Section 16 Planning Application for Proposed Mixed-Use Development (Proposed Flat with Permitted Commercial Uses) with Minor Relaxation of Building Height Restriction at Lot 4354 in D.D. 124, Kiu Tau Wai, Yuen Long (Application No. A/HSK/617)

Response to Departmental Comments

Drawing No.
FIGURE 3.2

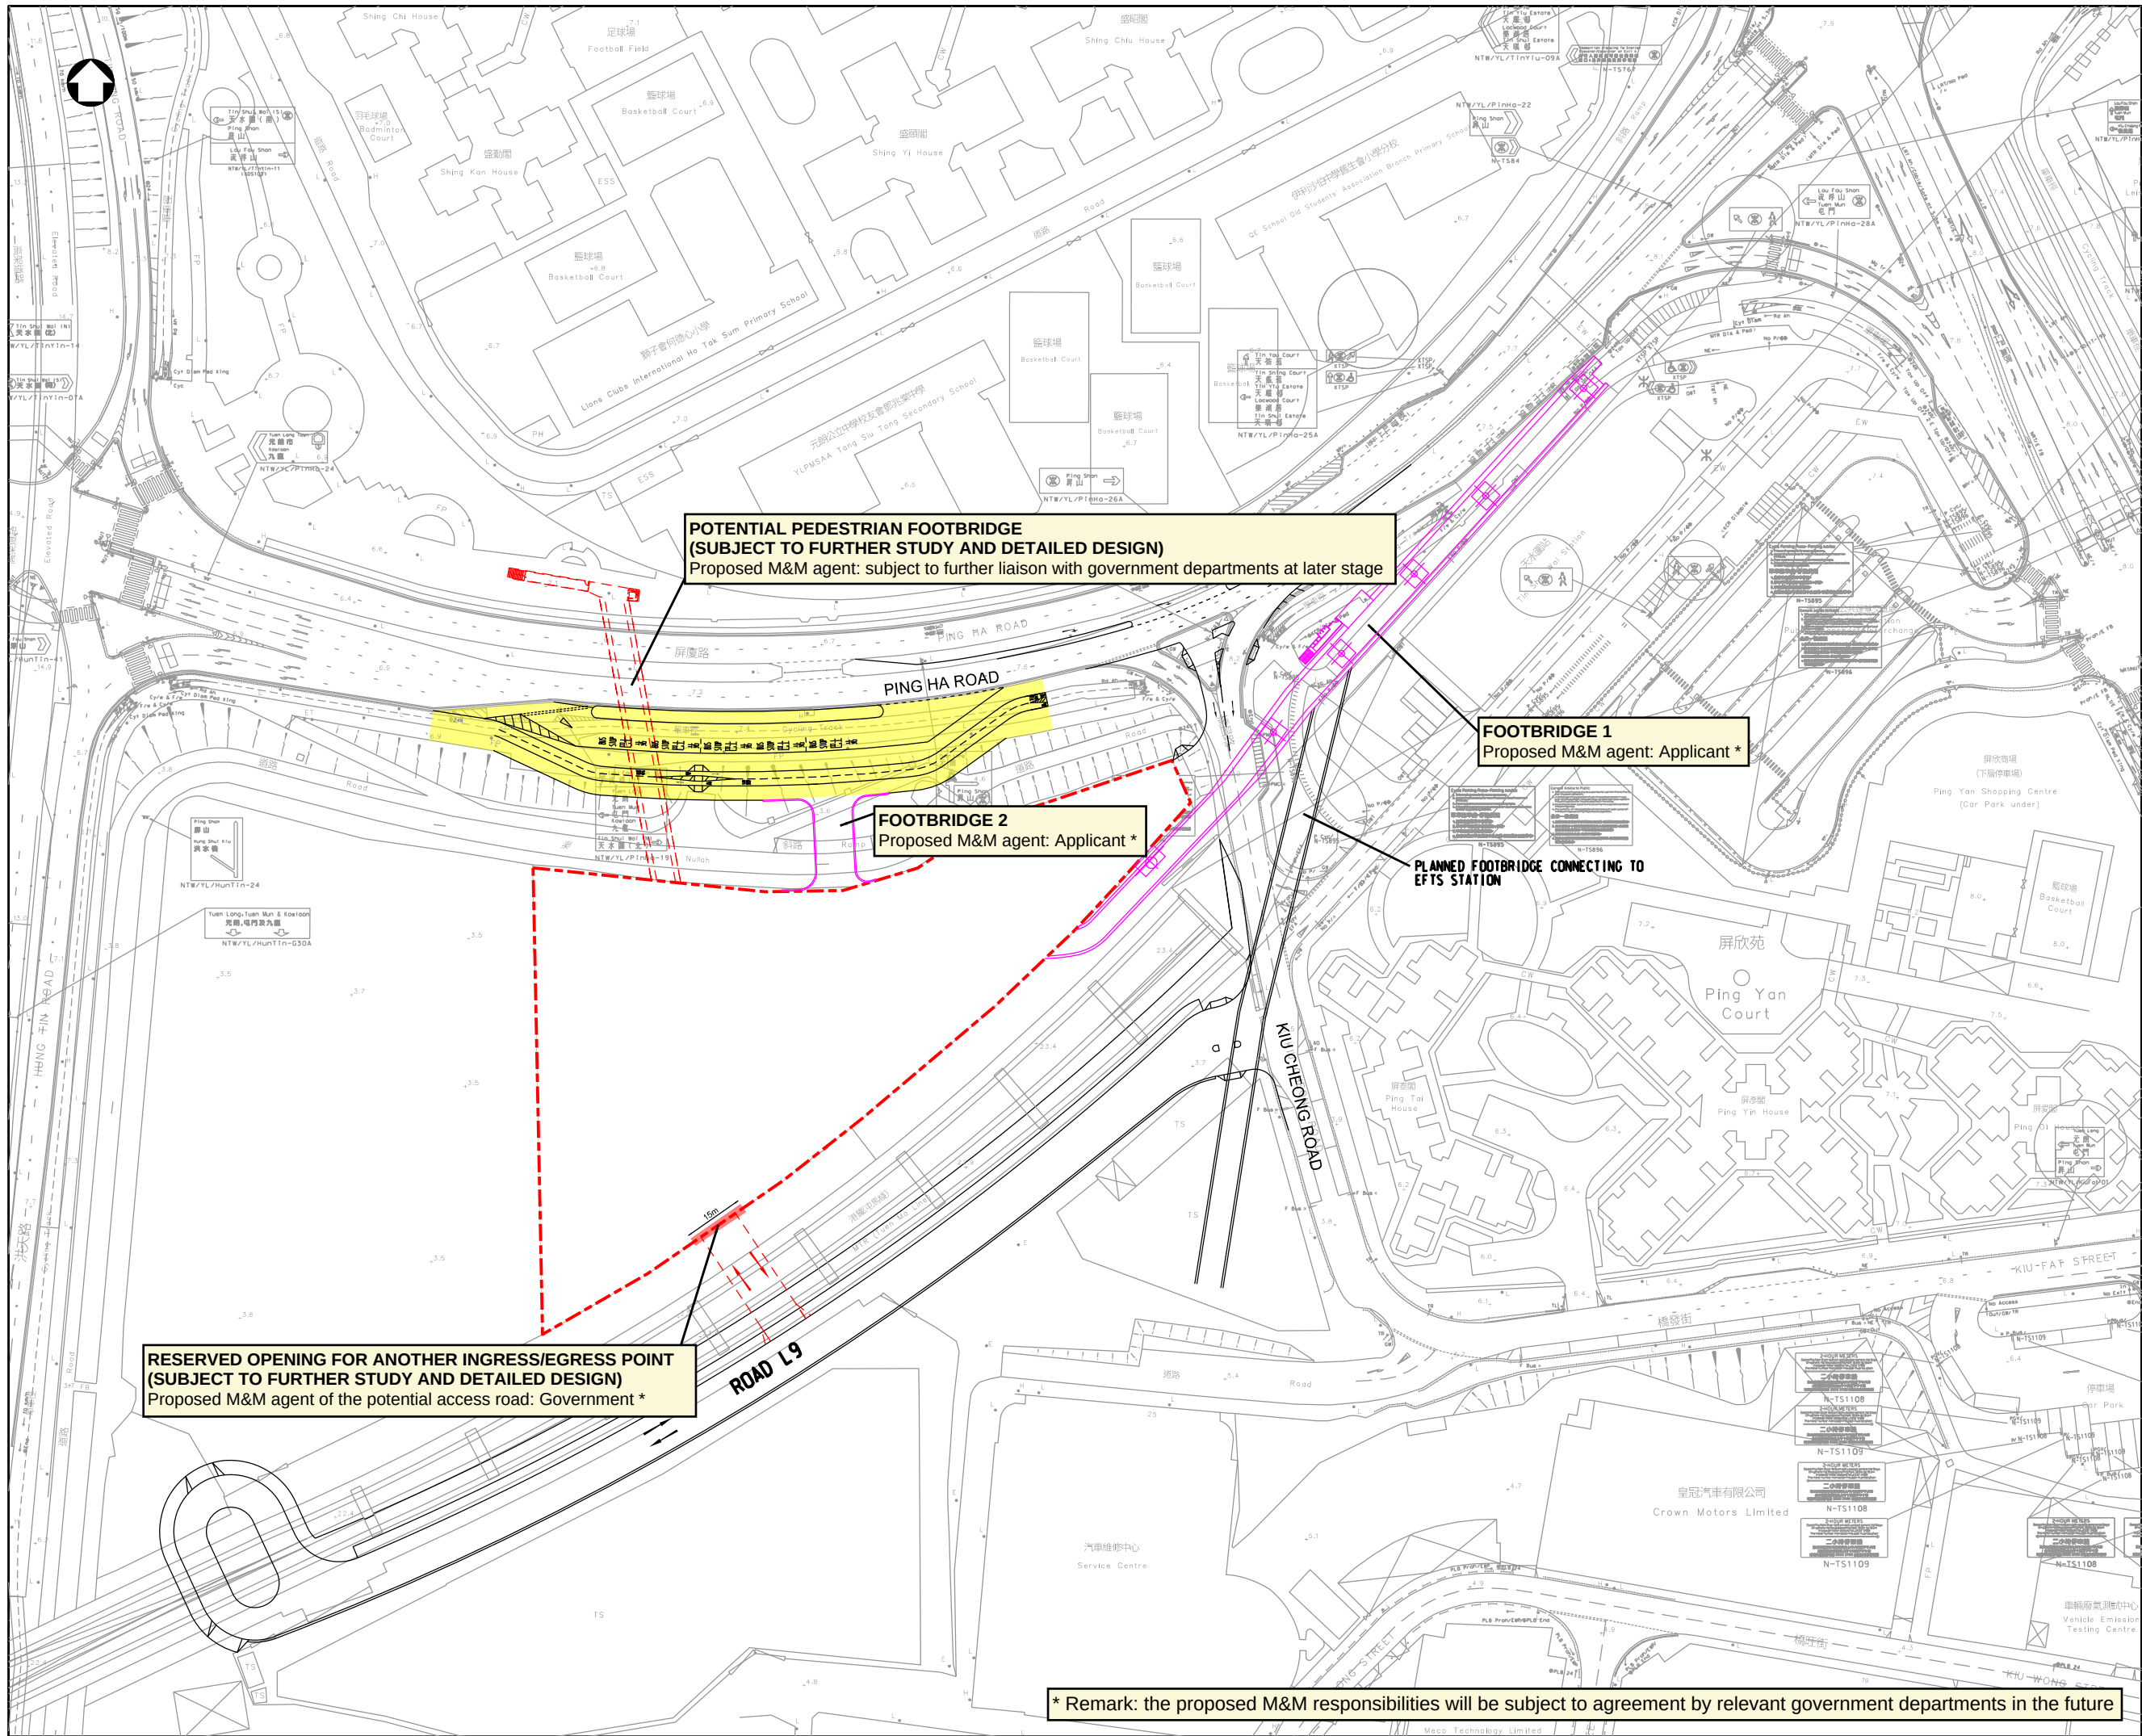
8.7	Figure 3.2: please indicate the proposed column location for the proposed bridge structures.	Noted. The proposed column location has been indicated in Figure 3.2 of the TIA replacement pages under Attachment 3 accordingly.

Table 1B: Proposed Shrubs and Groundcover Species

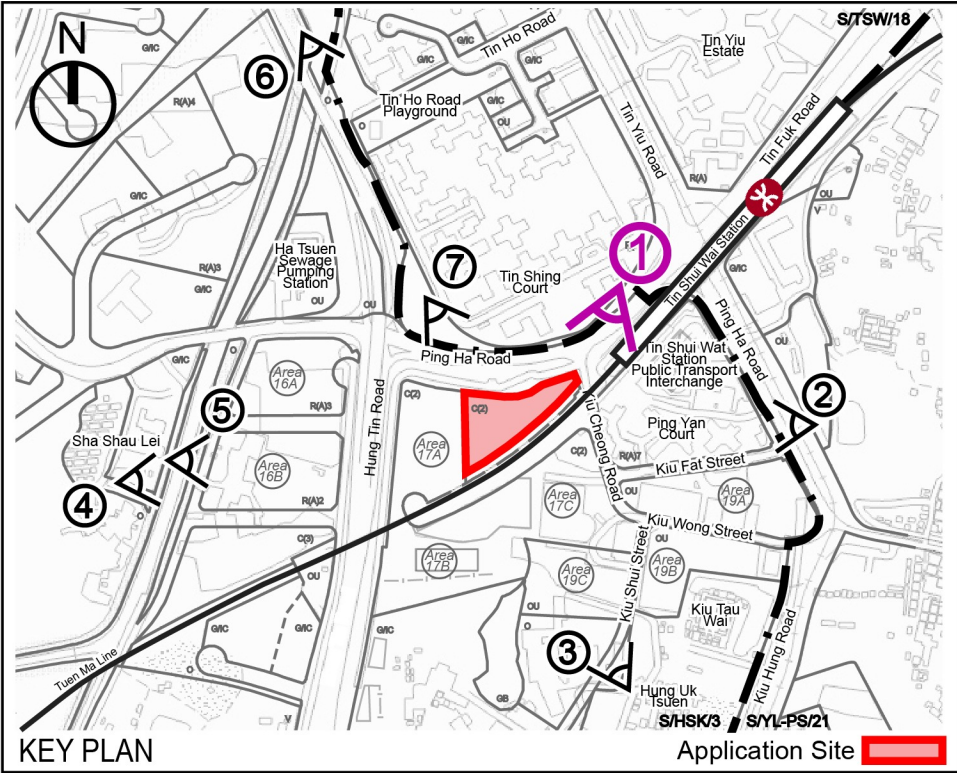
7.	Comments of Planning Department – Urban Design and Landscape	
	<u>Landscape</u>	
7.1	The Chinese name of the proposed lawn species <i>Zoysia japonica</i> should read “朝鮮草” in Table 1B.	Noted. The LMP has been revised accordingly. Please refer to the replacement page of the LMP under Attachment 1 .
	<u>Urban Design and Visual</u>

FIGURE 2.5

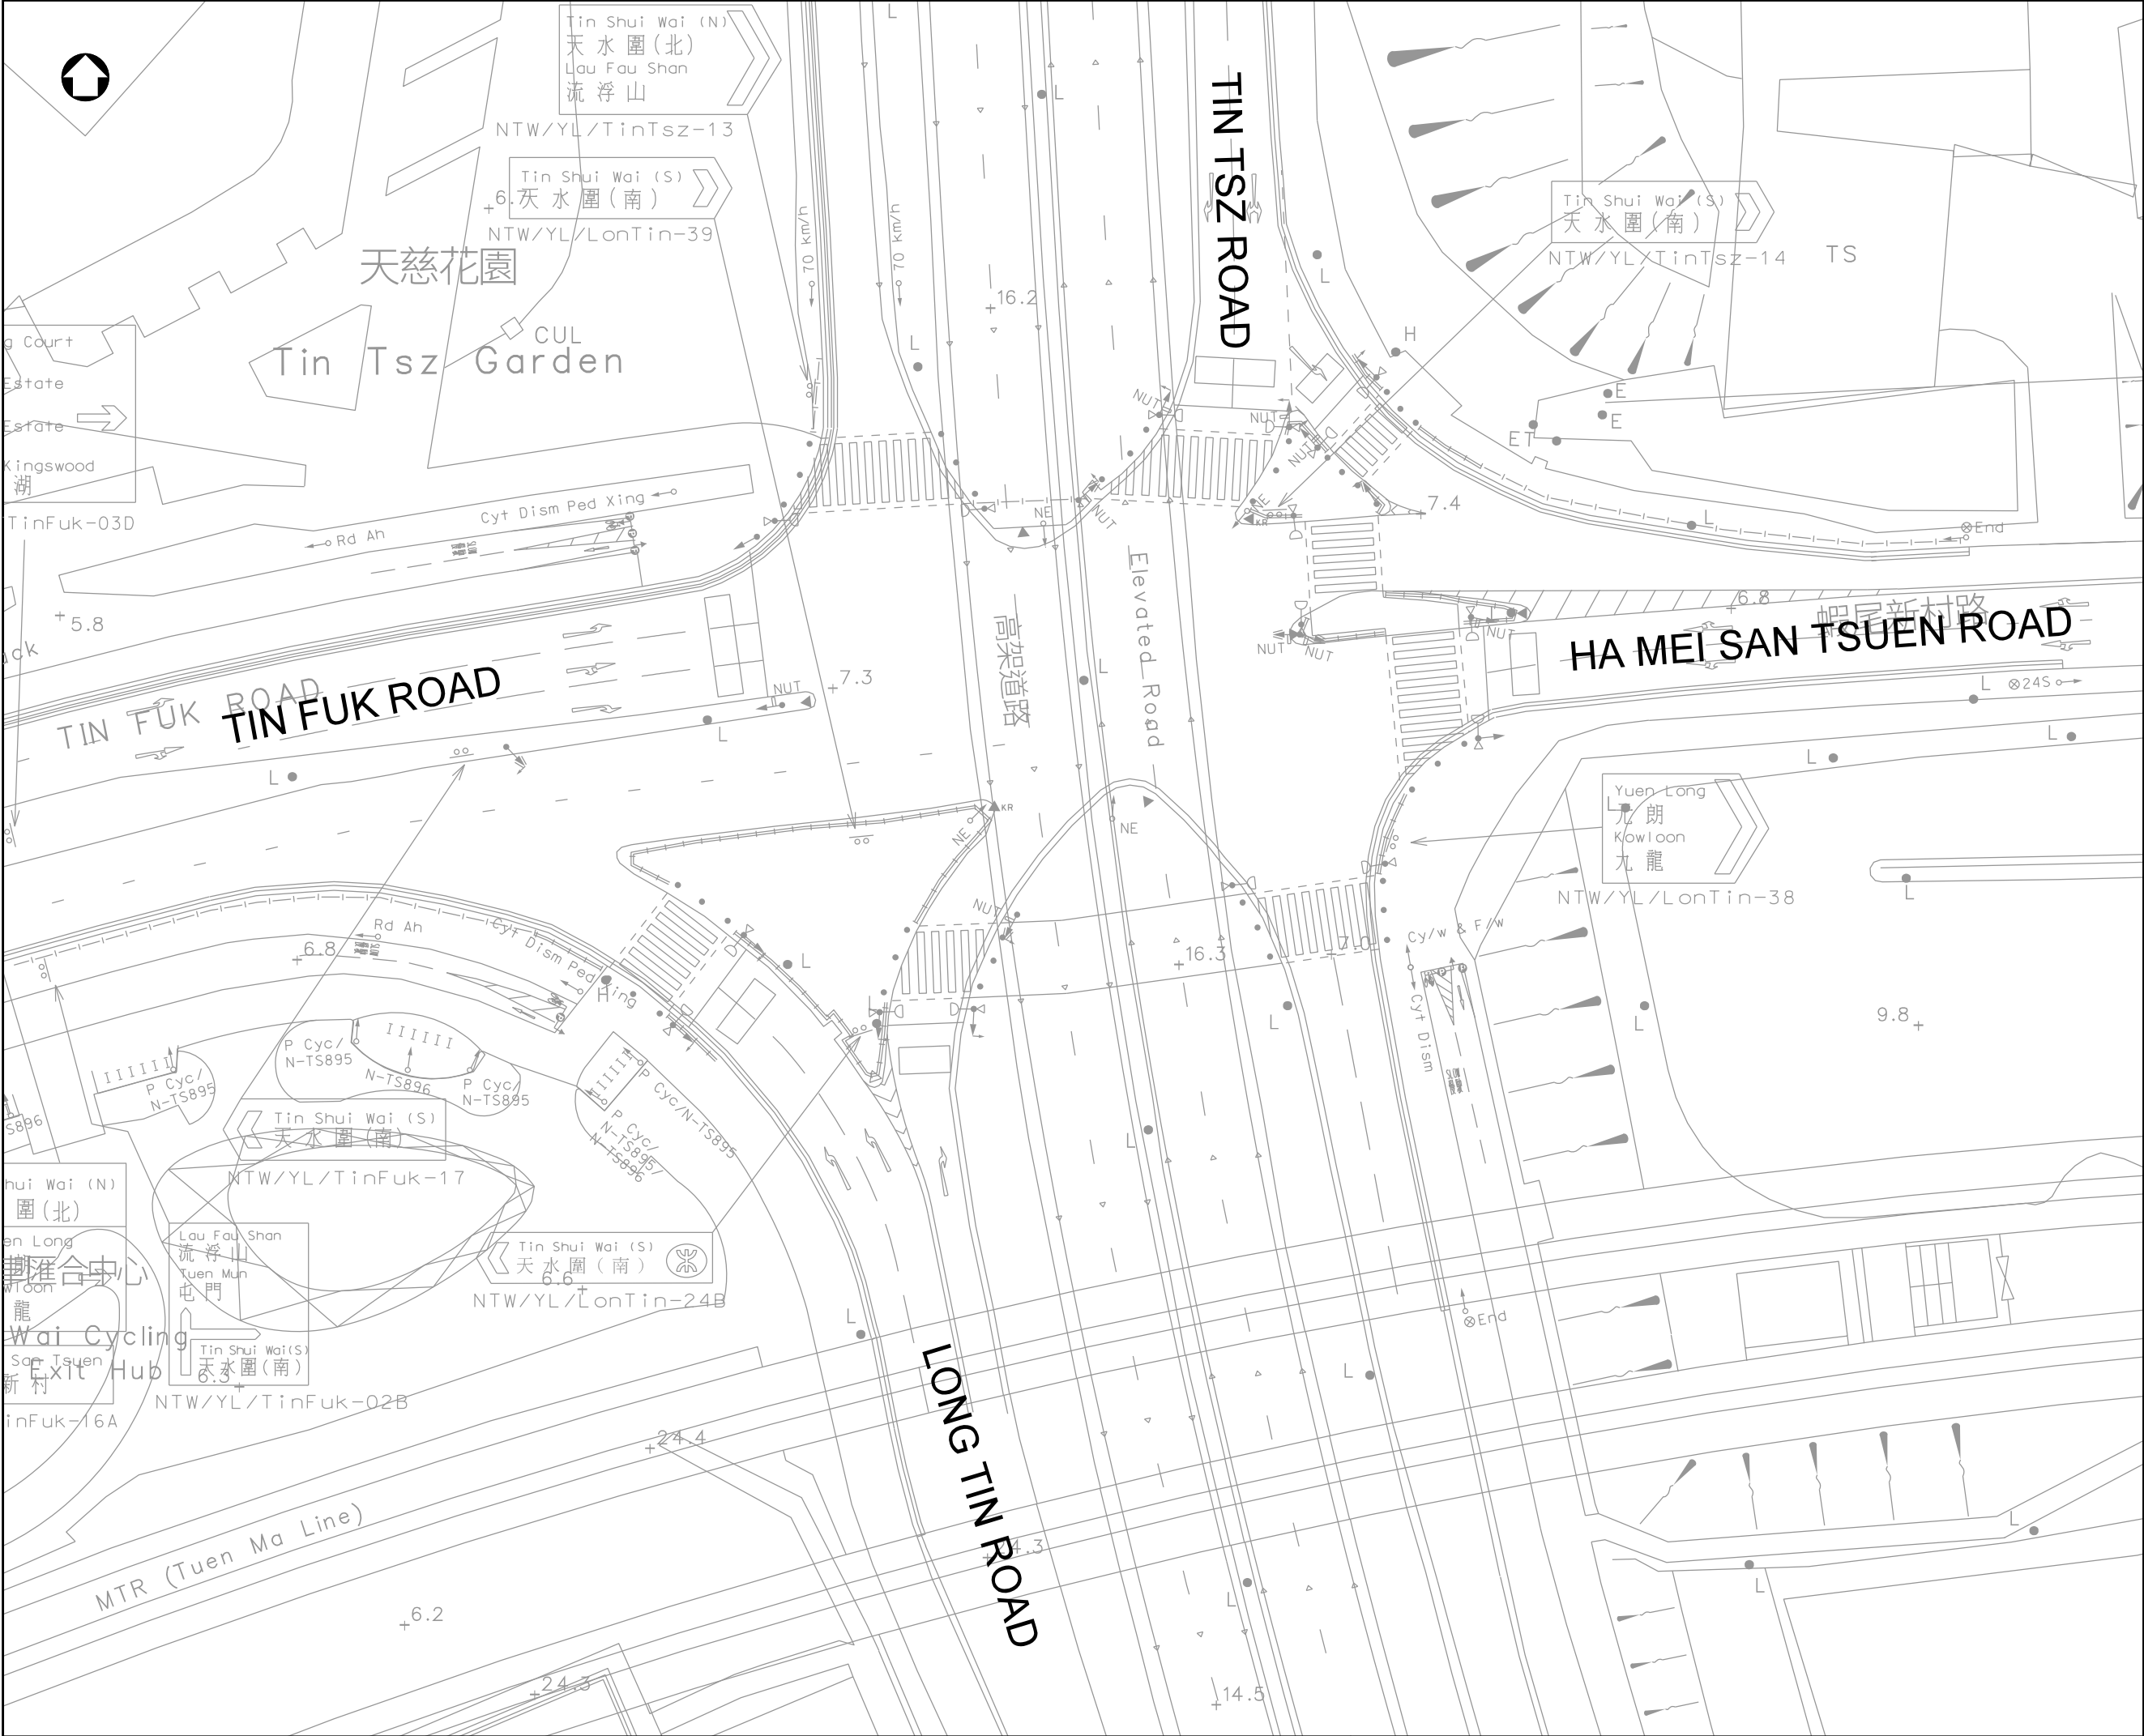
Departmental Comments	Responses to Comments
	<u>Comment on the Traffic Impact Assessment</u>	
8.4	Figure 2.5: there are typos on the road names. Please check.	Noted. Figure 2.5 of the TIA replacement pages under Attachment 3 has been revised accordingly.
